TRANS/WP.29/2005/54
6 April 2005

**PROPOSAL FOR DRAFT SUPPLEMENT 13 TO THE 02 SERIES OF
AMENDMENTS TO REGULATION No. 48**

(Installation of lighting and light-signalling devices)

Transmitted by the Working Party on Lighting and Light-Signalling (GRE)

Apparent surfaces of lighting units 1 through 11 of an AFS (example)

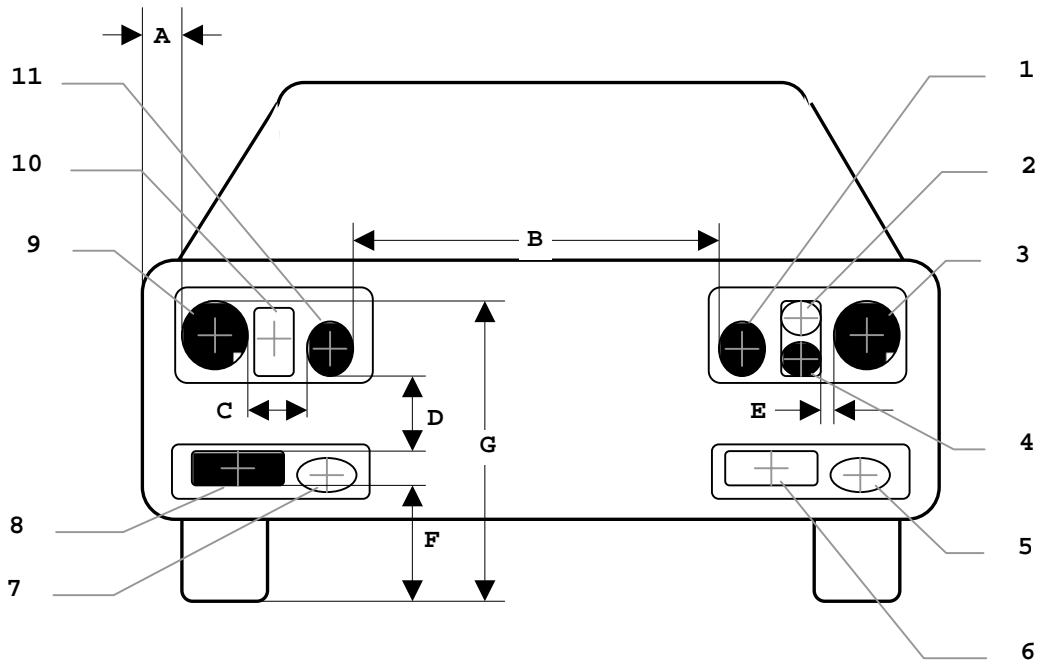
- 6.22.4.1.1. Two symmetrically placed lighting units shall be positioned at a height in compliance with the requirements of the relevant paragraphs 6.1.4. and 6.2.4., where "Two symmetrically placed lighting units" shall be understood to be two lighting units, one on each side of the vehicle, positioned such that the (geometric) centres of gravity of their apparent surfaces are at the same height and at the same distance from the vehicle's longitudinal median plane within a tolerance of 50 mm, each; their light emitting surfaces, illuminating surfaces, and light outputs, however, may differ.

- 6.22.4.1.2. Additional lighting units, if any, on either side of the vehicle shall be positioned at a distance not exceeding 140 mm ^{7/} in horizontal direction (E in the figure) and 400 mm in vertical direction above or below (D in the figure) from the nearest lighting unit;

- 6.22.4.1.3. None of the additional lighting units described in paragraph 6.22.4.1.2. above shall be positioned lower than 250 mm (F in the figure) nor higher than indicated in paragraph 6.2.4.2. of this Regulation (G in the figure) above the ground;

- 6.22.4.1.4. Additionally, in width:
- for each mode of the passing beam lighting:
the outer edge of the apparent surface of at least one lighting unit on each side of the vehicle shall not be more than 400 mm from the extreme outer edge of the vehicle (A in the figure); and,
the inner edges of the apparent surfaces in the direction of the reference axes shall be not less than 600 mm apart. This does not apply, however, for M₁ and N₁ category vehicles; for all other categories of motor vehicles this distance may be reduced to 400 mm where the overall width of the vehicle is less than 1300 mm.

^{7/} In case of additional "two symmetrically placed lighting units" the horizontal distance may be 200 mm (C in the figure).

Lighting units being simultaneously energized for a given lighting mode:

- No. 3 and 9: (two symmetrically placed lighting units)
- No. 1 and 11: (two symmetrically placed lighting units)
- No. 4 and 8: (two additional lighting units)

Lighting units not being energized for said lighting mode:

- No. 2 and 10: (two symmetrically placed lighting units)
- No. 5: (additional lighting unit)
- No. 6 and 7: (two symmetrically placed lighting units)

horizontal dimensions in mm:

- $A \leq 400$
- $B \geq 600$, or, ≥ 400 if vehicle overall width < 1300 mm, however
no requirement for category M1 and N1 vehicles
- $C \leq 200$
- $E \leq 140$

vertical dimensions in mm:

- $D \leq 400$
- $F \geq 250$
- $G \leq 1200$
